UNITED STATES PATENT AND TRADEMARK OFFICE

APPLICATION NO.	FILING DATE	FIRST NAMED INVENTOR	ATTORNEY DOCKET NO.	CONFIRMATION NO.
10/608,671	06/27/2003	Michael J. Pugia	MSA-3452	5201
7590 05/17/2006			EXAMINER	
Elizabeth A. Levy Bayer HealthCare LLC Two Edgewater Drive Norwood, MA 02060-4637			SINES, BRIAN J	
			ART UNIT	PAPER NUMBER
			1743

Office Action Summary

DETAILED ACTION

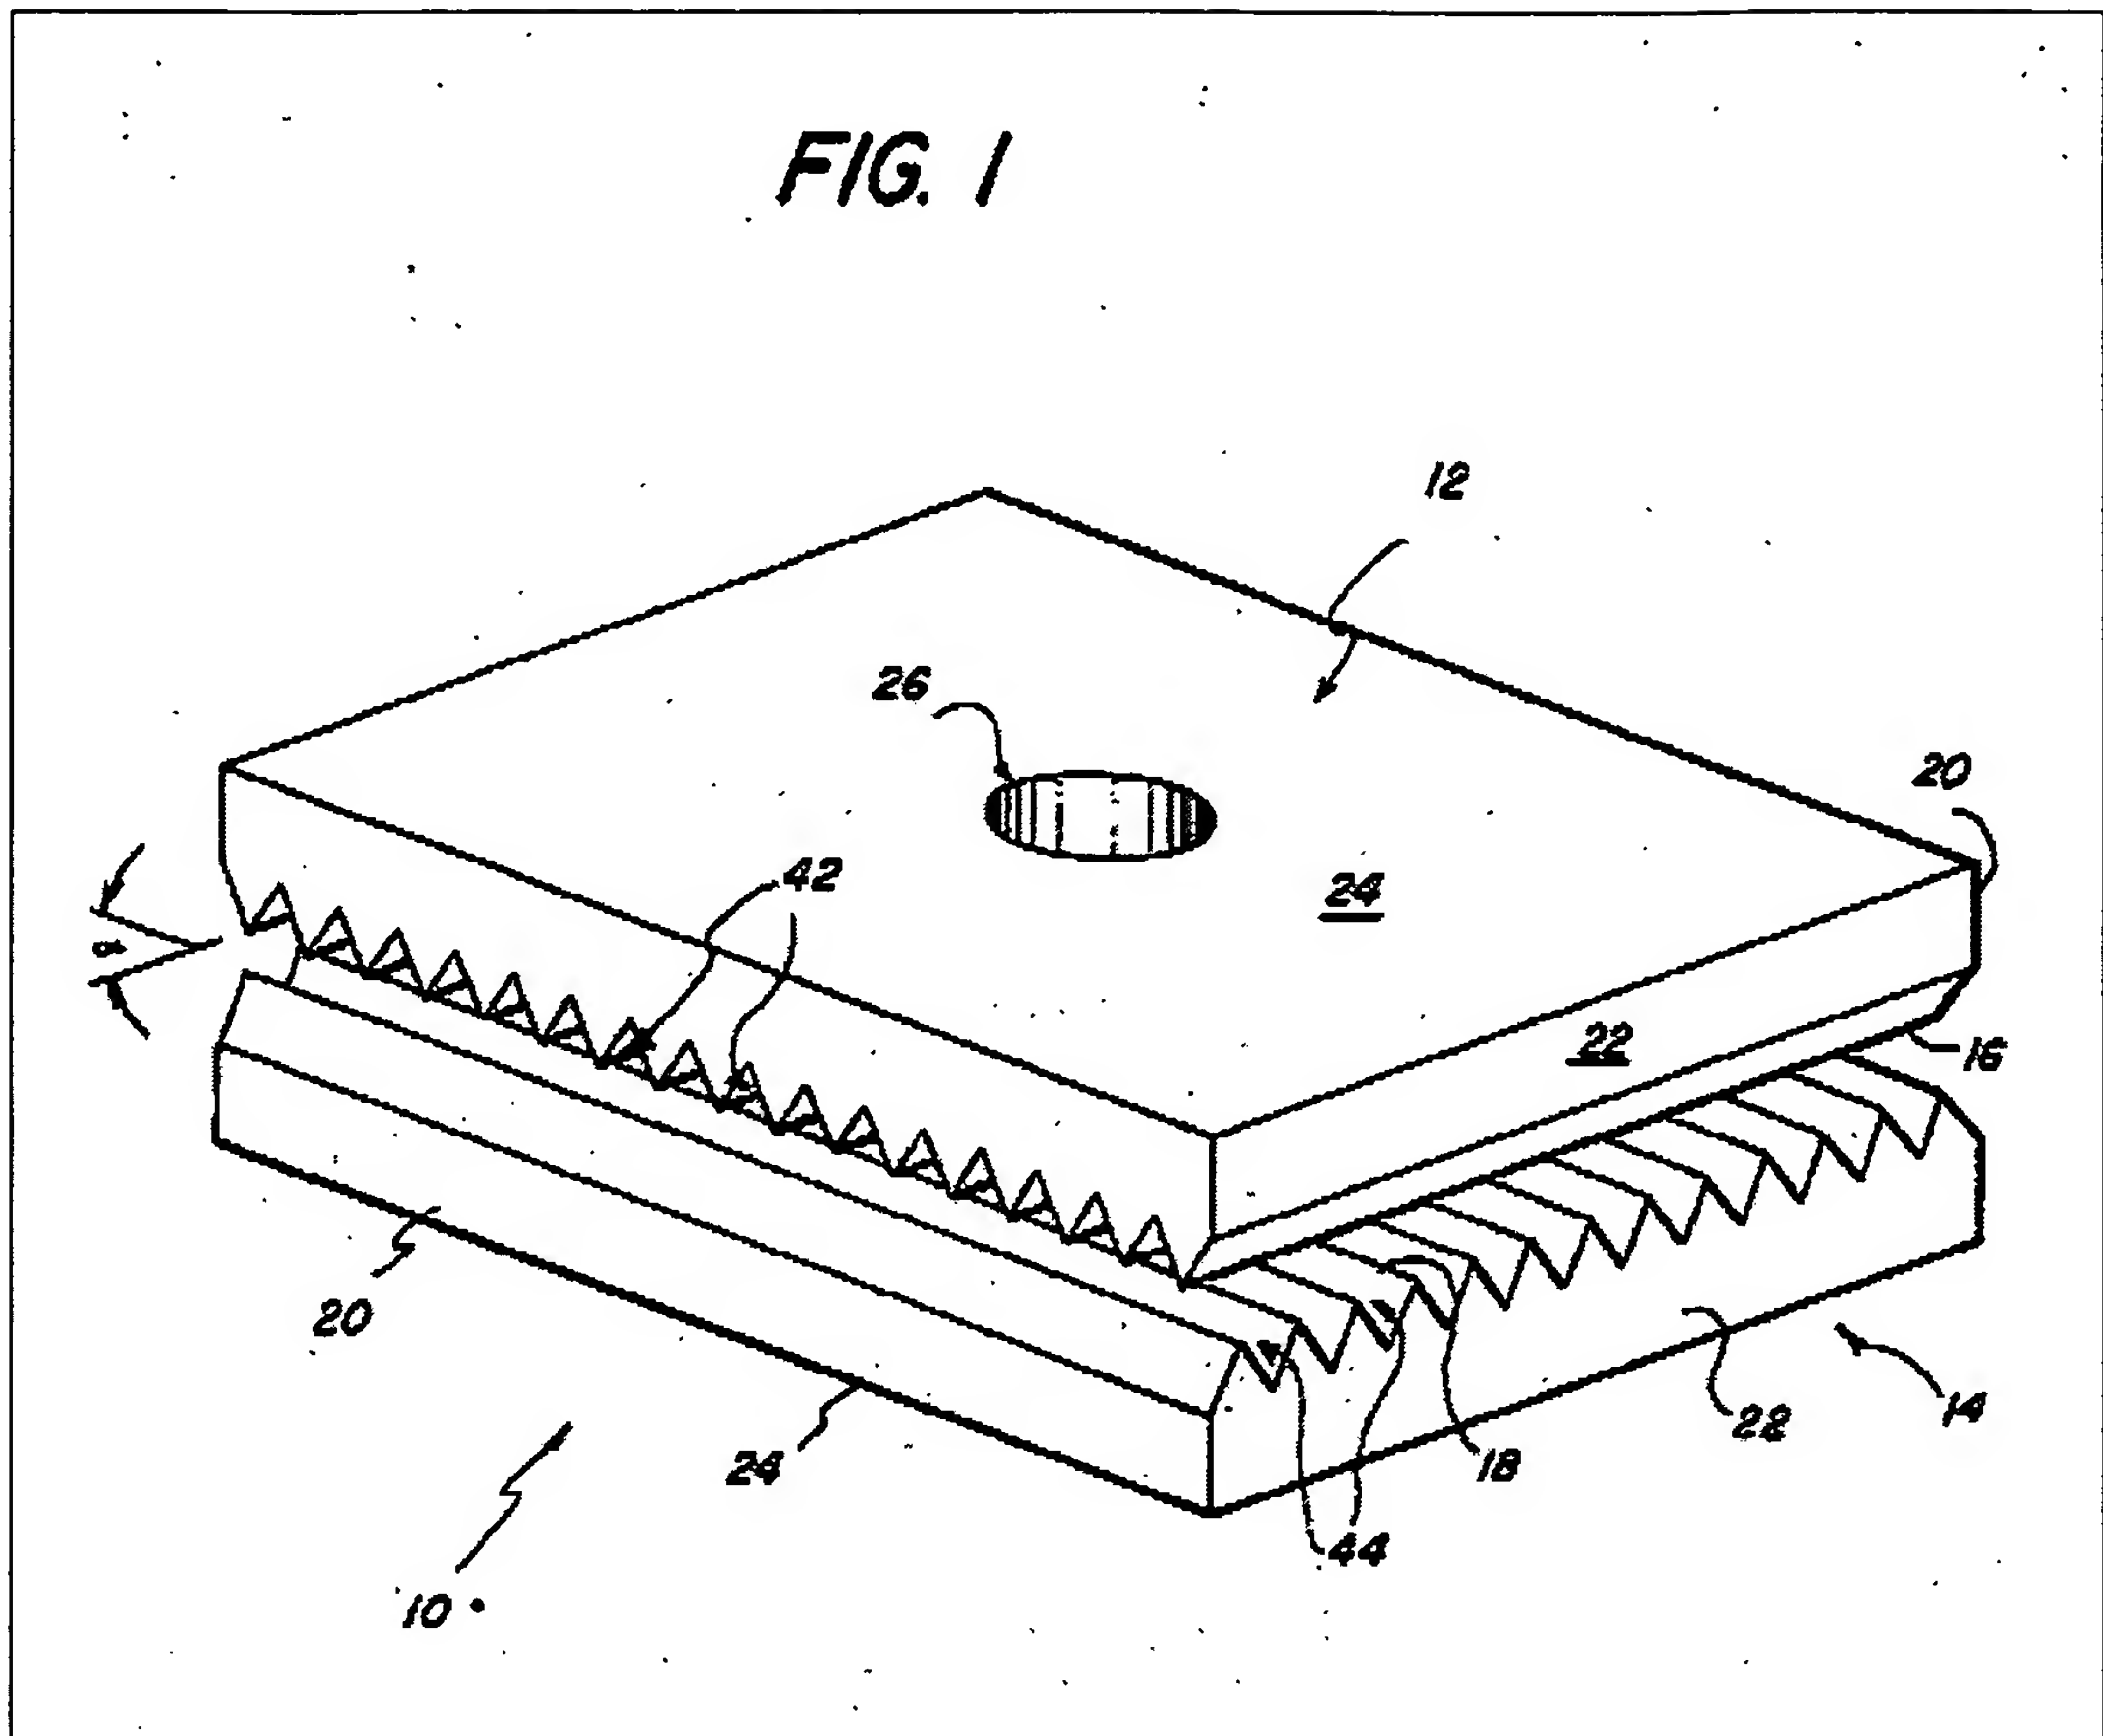
Regarding claims 1 and 2, Columbus '029 teaches a microfluidic apparatus (10) comprising: an inlet port (aperture 26); a capillary passageway (e.g., the sidewalls of the inlet port 26 extending through top member 12) in fluid communication with the inlet port (26); an inlet chamber (e.g., the spacing between interior surfaces 16 & 18) in fluid communication with the capillary passageway, wherein the inlet chamber comprises means (grooves 42 & 44) for uniformly distributing sample fluid across the chamber and displacing air from the chamber; and at least one vent passageway (e.g., the space between members 12 & 14 left exposed at either edge 20 or 22) or additional aperture (e.g., 26b') (see col. 1, line 1 – col. 6, line 60; figures 1 – 3).

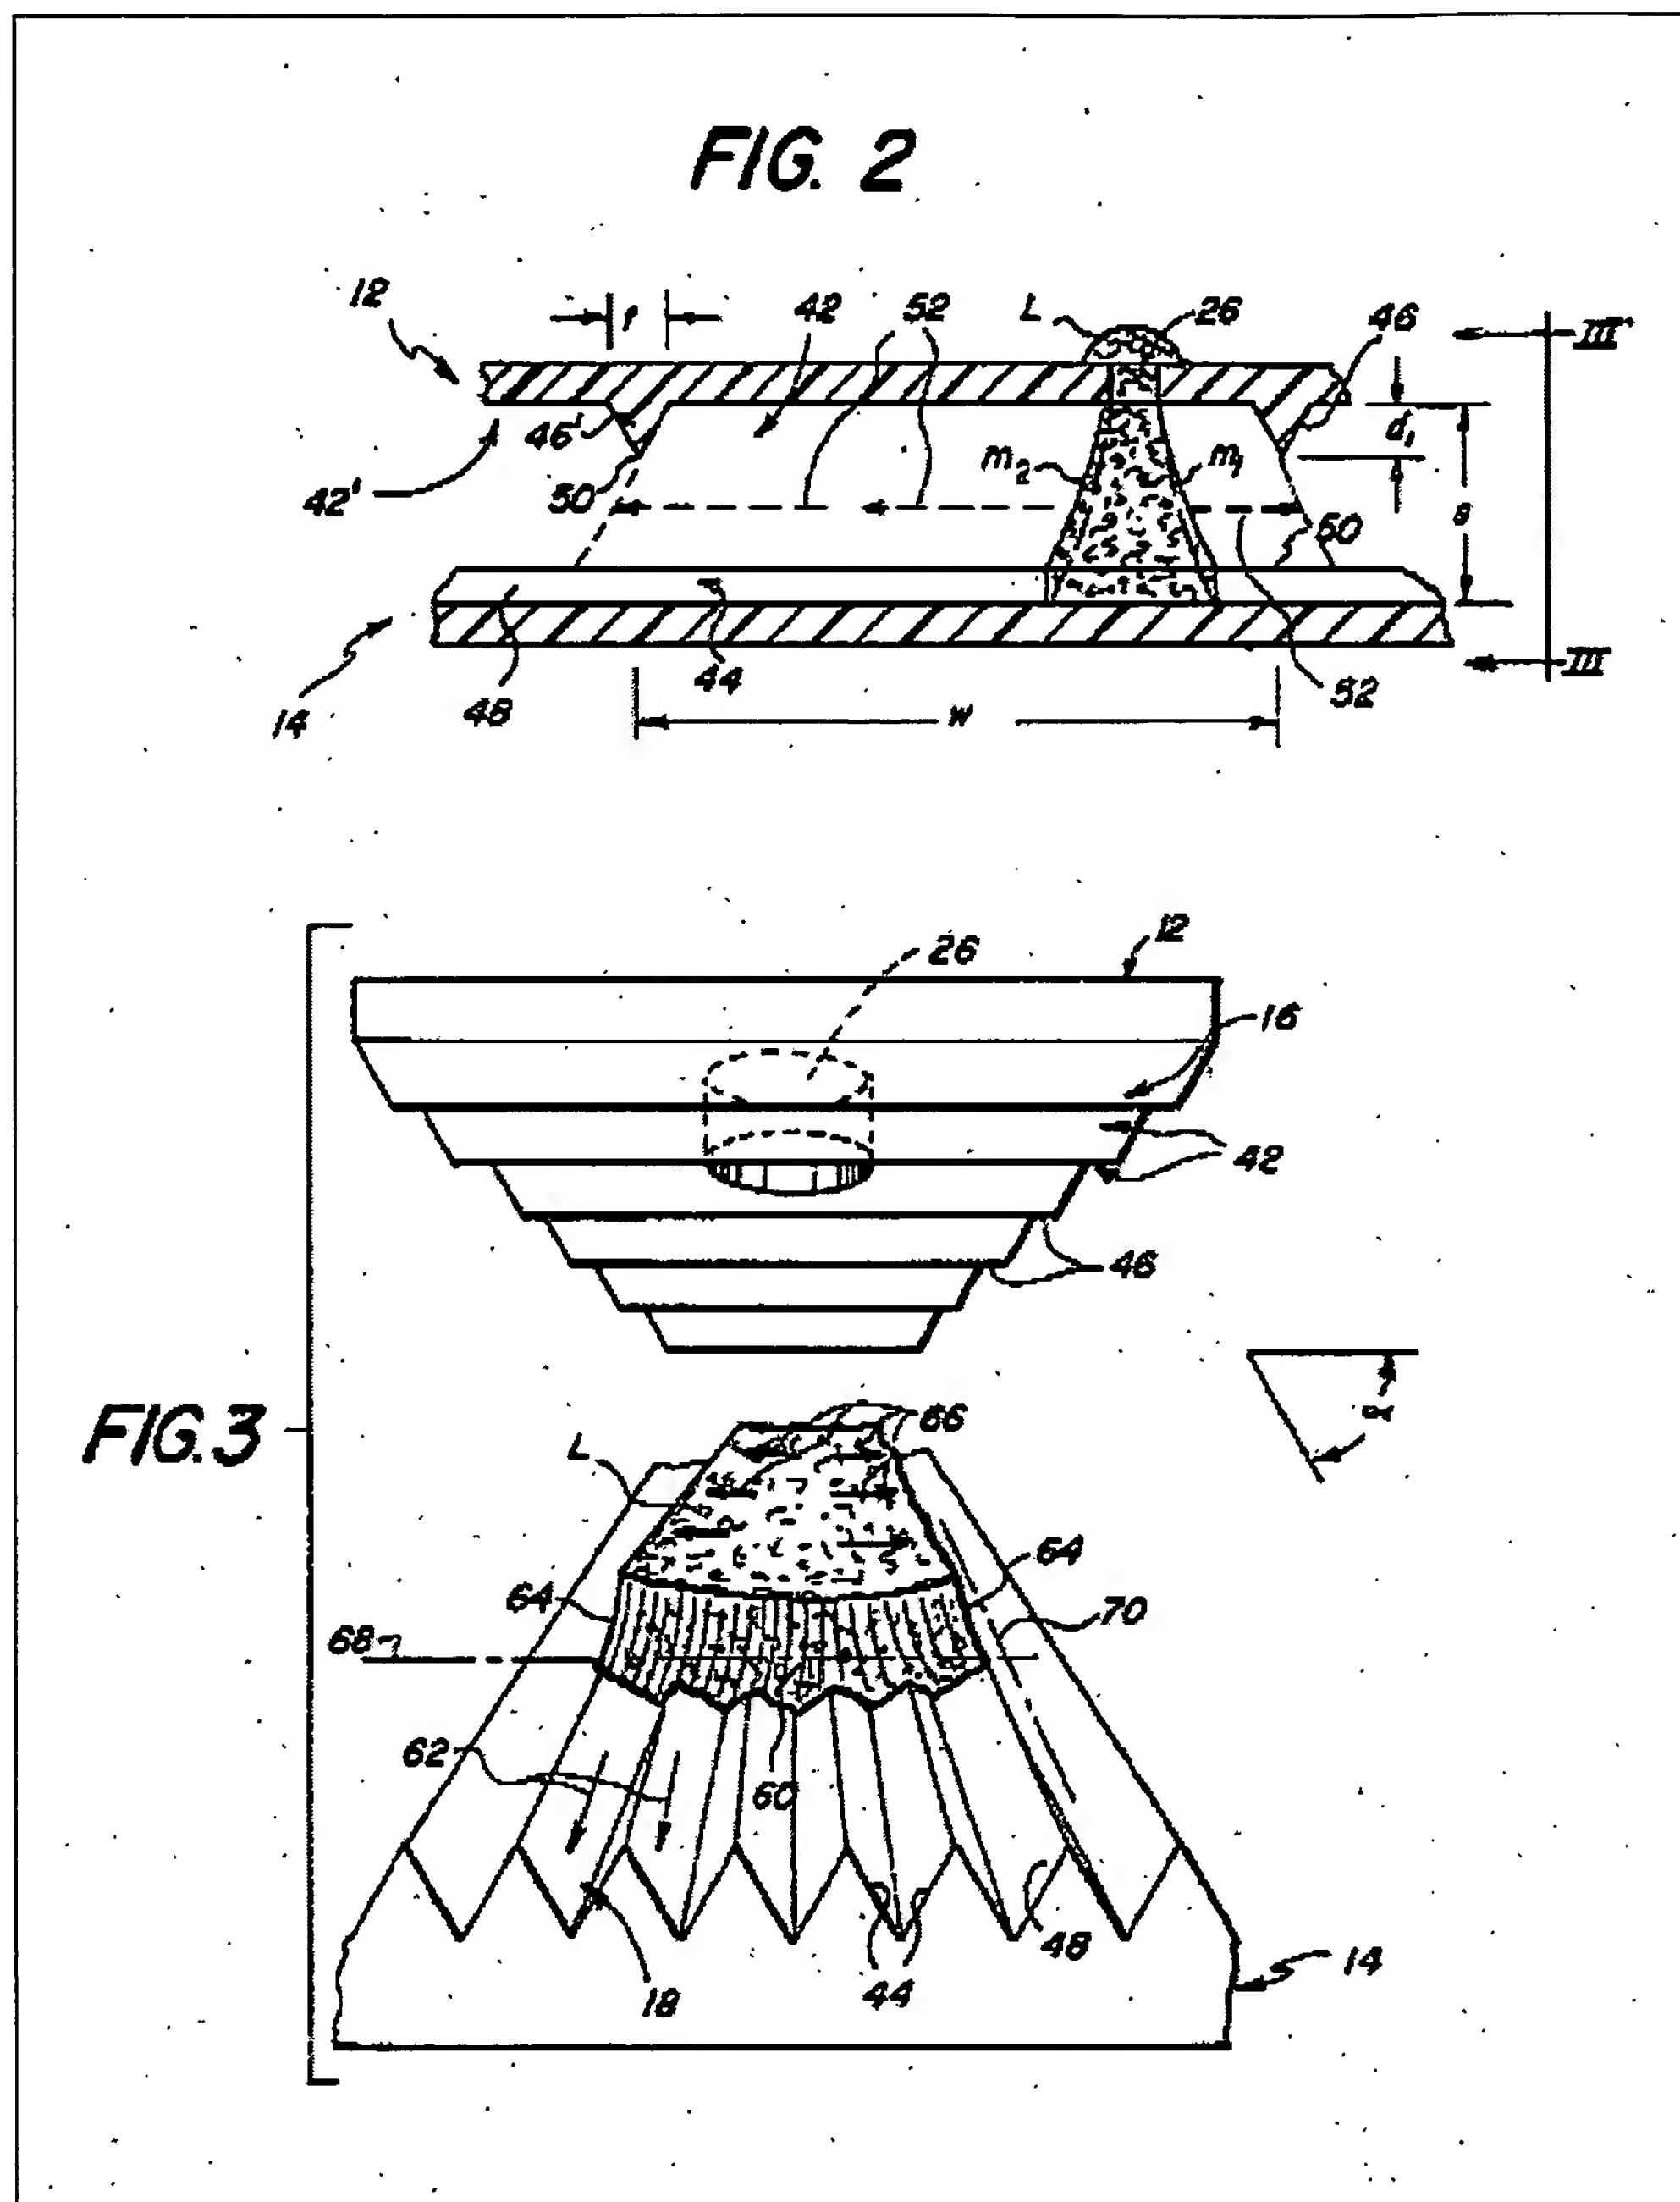
As shown in figures 10 and 11, Columbus '029 further anticipates the incorporation of an enclosed inlet chamber (apertures 26b or 26b') at one side thereof the device.

As shown in figure 10, Columbus '029 anticipates an enclosed passageway. Walls 124 & 144 enclose passageway defined by 44b (see col. 11, lines 1 – 16; fig. 10). Columbus '029

teaches that walls 124 can be additional closure walls, thereby forming an enclosed structure (see col .12, lines 47 – 57).

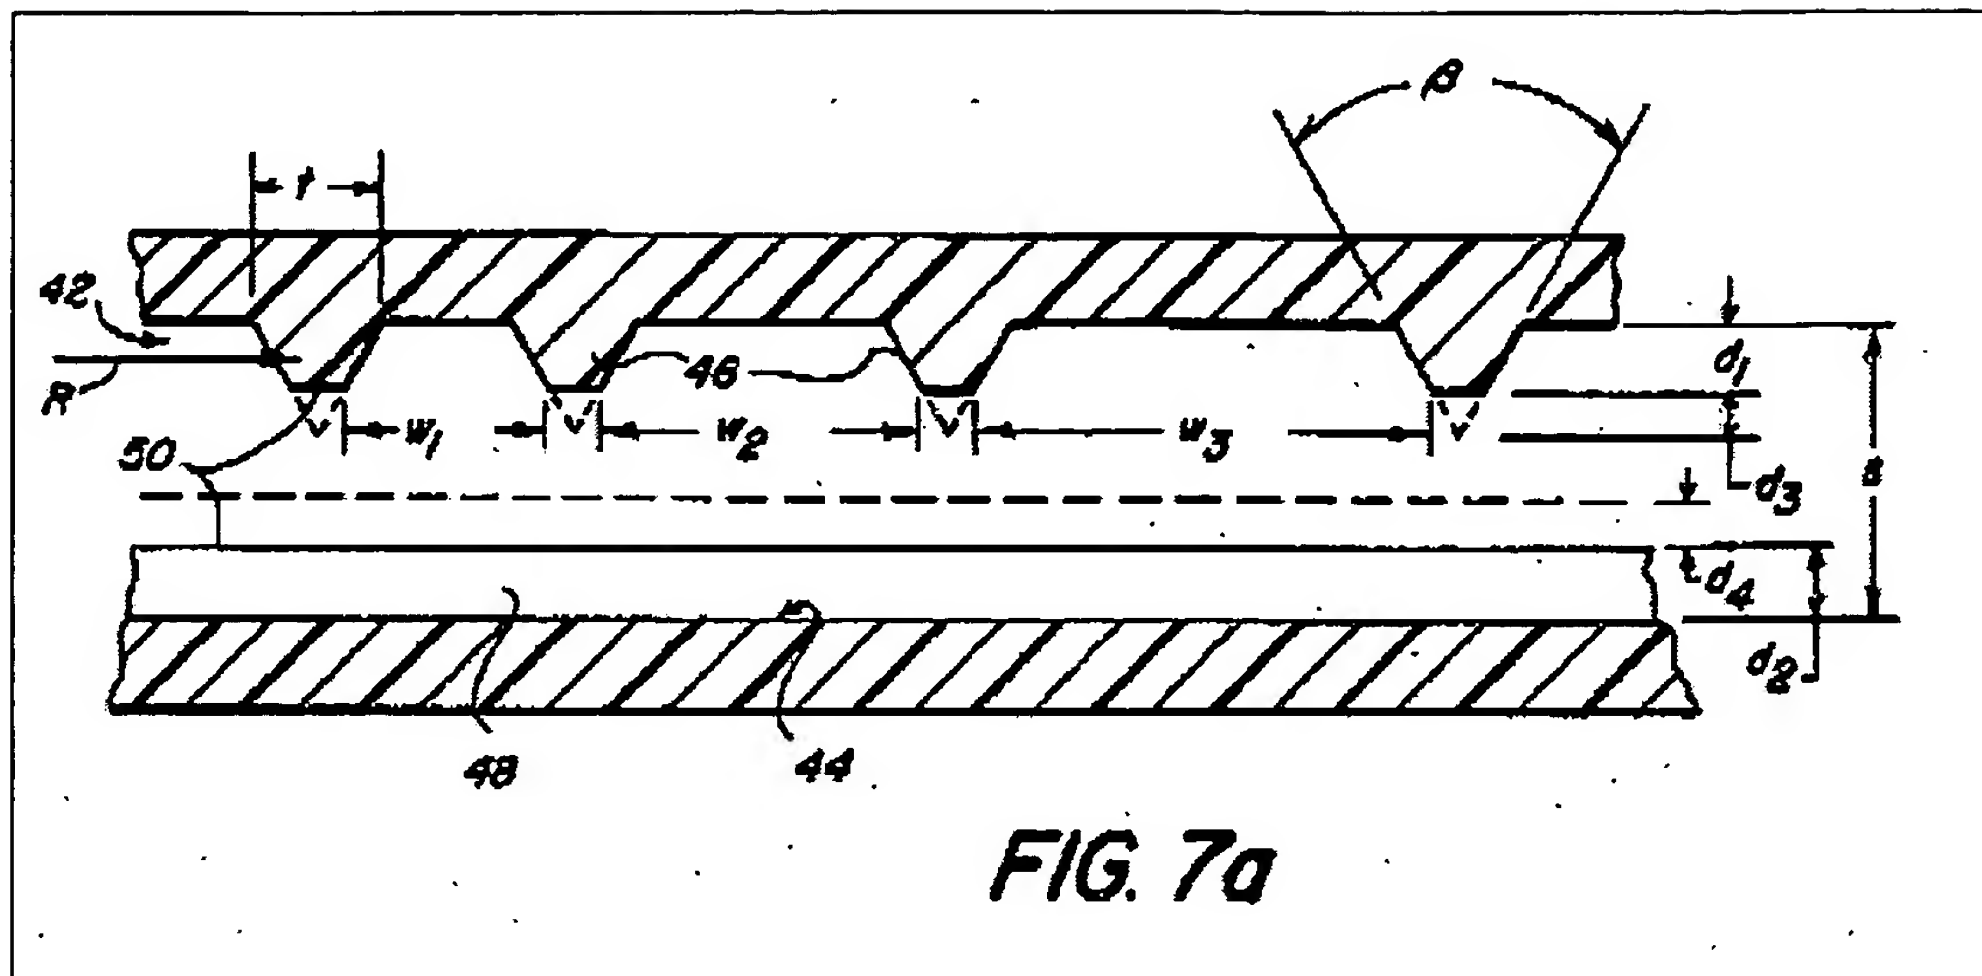
Regarding claim 3, as shown in figure 7a, Columbus '029 further teaches the incorporation of weir structures (truncated ridges 46) within the apparatus (see col. 8, lines 1 – 51).

FIG. 1.

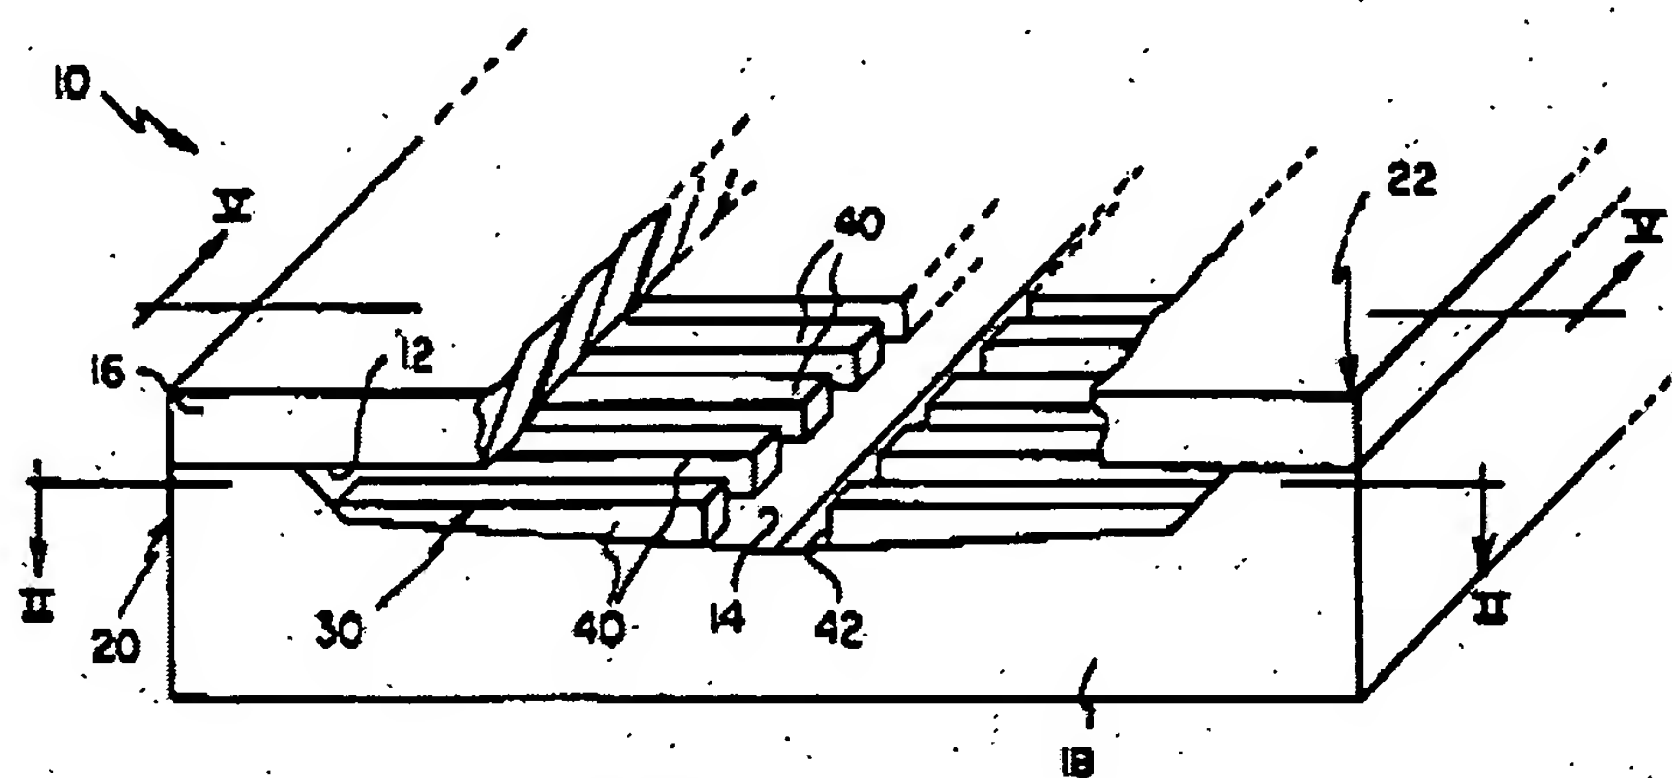
Regarding claim 2, Columbus '476 teach the incorporation of groove or slot structures (142g') within the apparatus. Columbus '476 anticipates an enclosed passageway (e.g., enclosed

transport zone 30) via the placement of cover top member 16 and bottom member 18 (see col. 3, lines 25 – 50; figures 1, 2 & 5).
